To: **Environmental Committee**
Through: **Dave Schletty, Asst. Parks and Rec. Director**
From: **Melissa Sonnek, City Planner**
Date: **January 6, 2021**

Case 20-19 Site Plan for the Construction of a Car Wash at 1949 Robert St. (Crew Carwash)

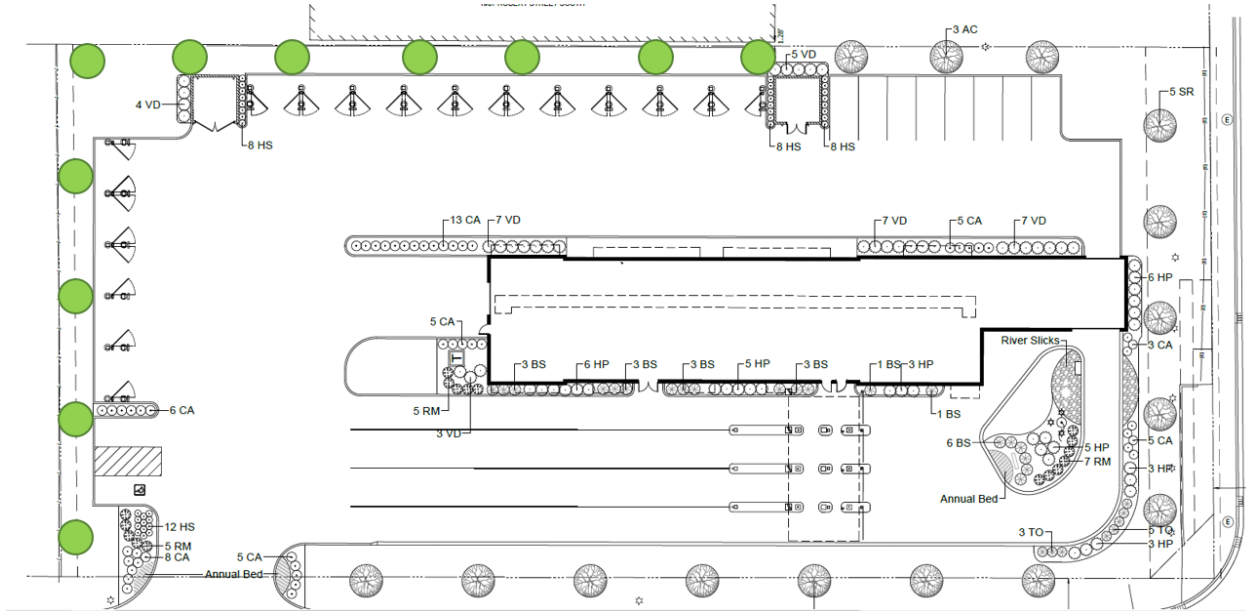
The subject property measures 1,055 lineal feet of property line, which equates to 53 trees. The applicant is proposing 15 trees, which falls short of the minimum requirement. City Staff would like to see a minimum of 11 more trees (26 trees), which can be accomplished by continuing the planting and spacing pattern found on the south and east sides of the site to the north and west sides, as shown by the green circles in the image below.

City Staff acknowledges that this site is one that is particularly automobile oriented and has a large amount of impervious surface, and therefore would like to see additional landscaping to offset the effects of said items.
